## SMITH MONROE & GRAY ENGINE S, INC.

## MEMORANDUM

SEATTLE BITE DRAINAGE

Regarding your question today about the note that is shown on our drawing 8-169-18 for the electrical connection for the sump. I submit the following.

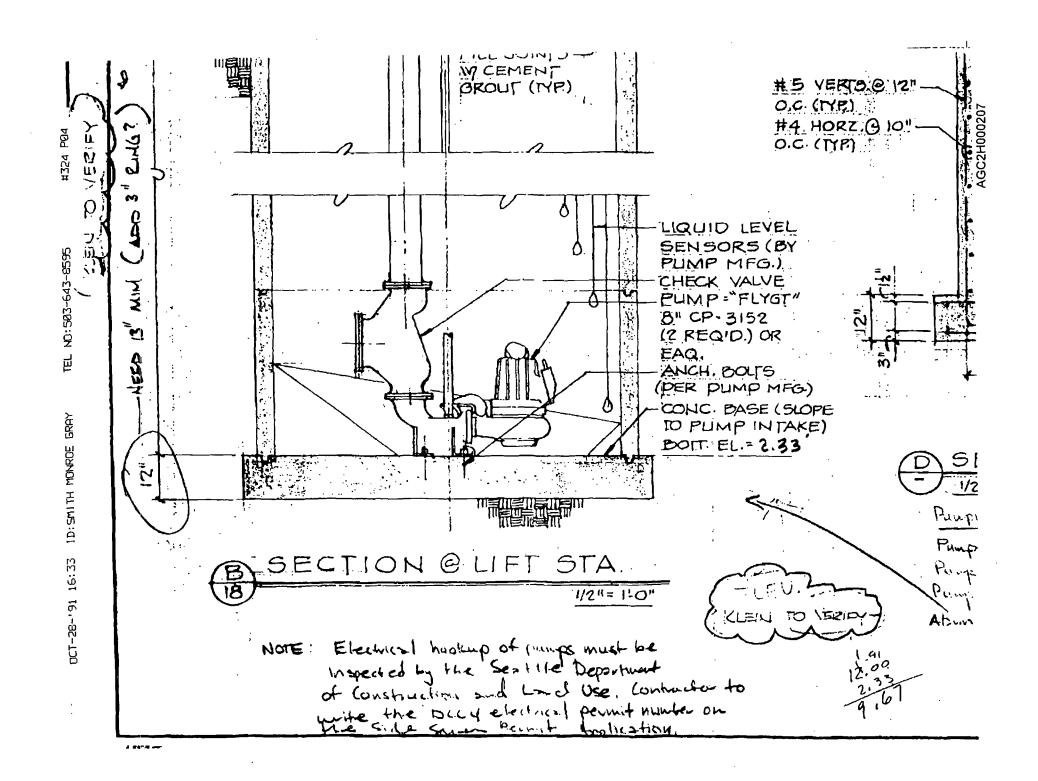
THESE HAVE BEEN REVIEWED BY MYSELF, NATE AND BAUGH.

On May 31, 1991 we forwarded to Ken Rone copies of the drawings for his review and comment. On June 13, 1991 (see transmittal attached) he returned those drawings including the above referenced drawing. The note that you refer to was "red-marked" on the drawing (see copy attached). Notice on the transmittal that en notes "These have been reviewed by myself, Nate and Baugh". I do not know who added the electrical note, I suspect it may have been Baugh, but perhaps Ken recalls.

I am not fully familiar with all the City regulations pertaining to this work; however, I suspect that If Baugh did add the note, it has some valid basis and perhaps they can help clarify the situation. The note, as I read it, indicates that BEFORE a connection can be made to the City system, the electrical permit must be in hand, and that (electrical) permit number must be included in the permit to connect to the City. This does not sound like an unreasonable request from the City to assure a properly connected system tying into their system. It is not unusual for the electrical contractor secure this permit.
